Virgil C. Summer Nuclear Station (VCSNS) Units 2 and 3  
Combined License Nos. NPF-93 and NPF-94  
Docket Nos. 52-027 & 52-028

Subject: VCSNS Units 2&3 LAR 13-29 Request for License Amendment and  
Exemption: Consolidation of IDS Spare Battery Termination Boxes

**Consolidation of IDS Spare Termination Boxes**

**(LAR 13-29)**

**UFSAR Tier 2 Figure 8.3.2-1, Sheet 2 of 2, Class 1E DC System One Line Diagram, excerpt from lower-center portion**

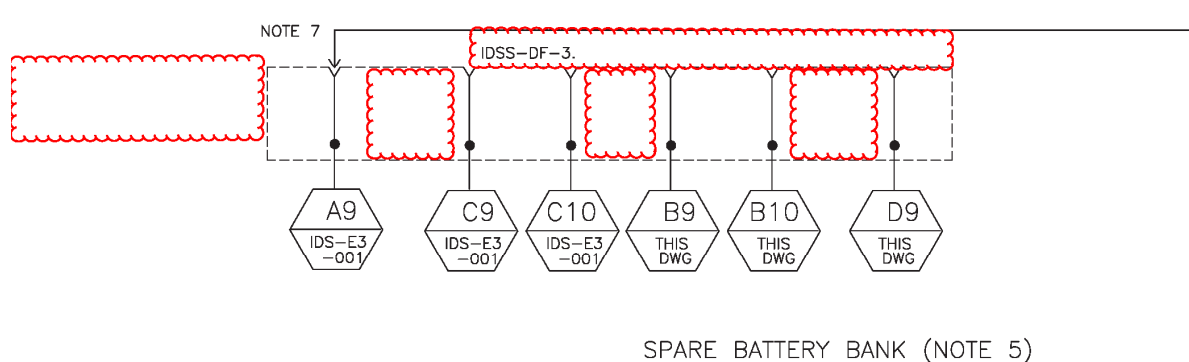
UFSAR Table 3.11-1 (Sheet 4), Table 3I.6-2 (Sheet 3), and Figure 8.3.2-1 (Sheet 2), are revised to replace the four Spare Termination Boxes with a single Spare Battery Termination Box.

Revise figure as shown below:

Revise Note 7 as shown below:

7. PLUG-IN LOCKING TYPE DISCONNECT IS PROVIDED TO CONNECT TO THE SPARE BATTERY TERMINATION BOX, IDSS-DF-3
